Report to the Plan Commission

April 22, 2013

1902 Tennyson Lane and 3802 Packers Avenue

Demolition Permit and Certified Survey Map (CSM)

Figure 2: Conceptual Street Layout Study - Sketch #1 (Prepared by the Planning Division)

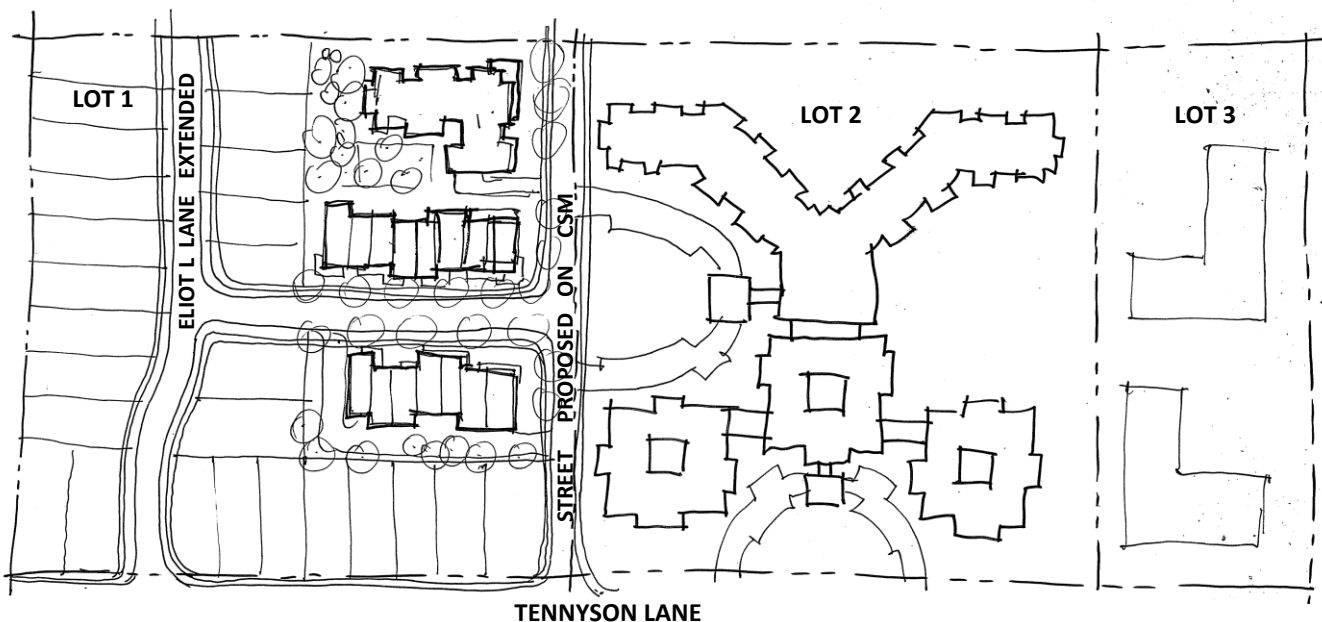
The first concept study (Figure 2) shows a future development pattern based on the midblock street proposed by the applicant. This sketch also shows the plan-recommended extension of Eliot Lane. With the spacing between the Eliot Lane extension and the proposed street, there would be enough room for a future east-west street that would allow development to front onto Tennyson Lane. Single-family homes currently front the opposite side of Tennyson Lane.

Figure 3: Conceptual Street Layout Study - Sketch #2 (Prepared by the Planning Division)

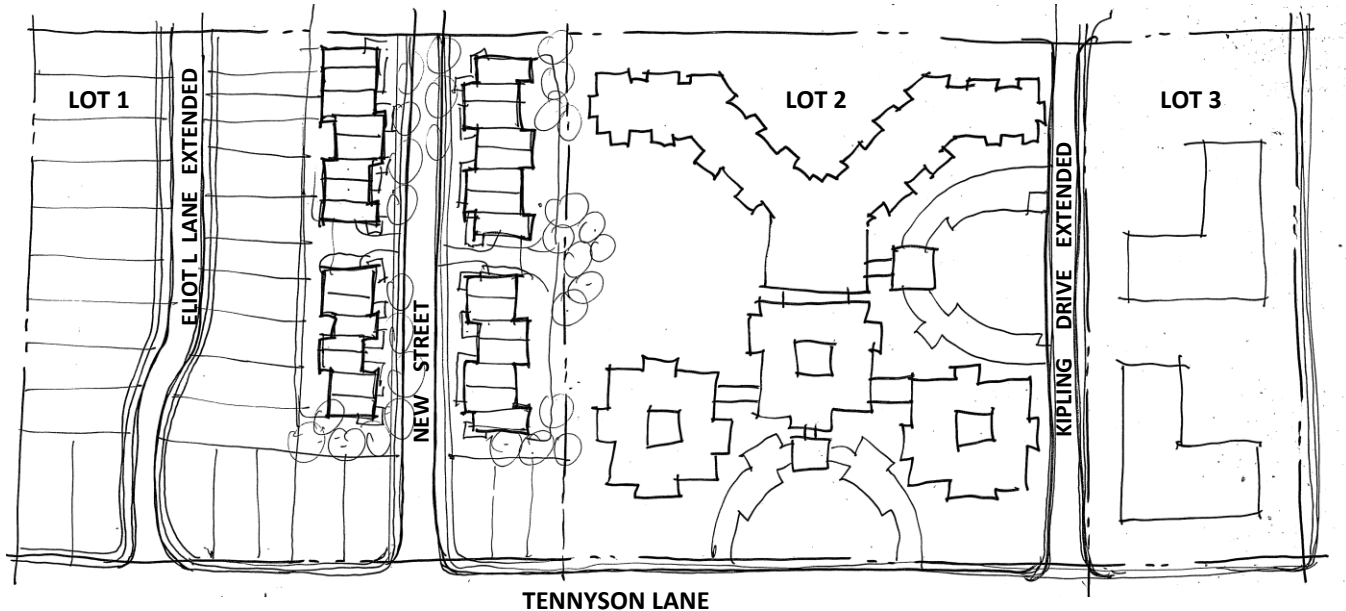
The second concept study (Figure 3) shows a future development pattern with three north-south streets, though not the north-south street proposed on this CSM. The midblock street is shifted to the west. As shown, development could still front onto Tennyson Lane. As on Figure 2, the plan-recommended extension of Eliot Lane is shown. Also shown in this concept is a potential extension of Kipling Drive. Though not specifically recommended in the adopted neighborhood plan, this street connection is implied in one of the Raemisch property development concepts in Figure 1 of this report.
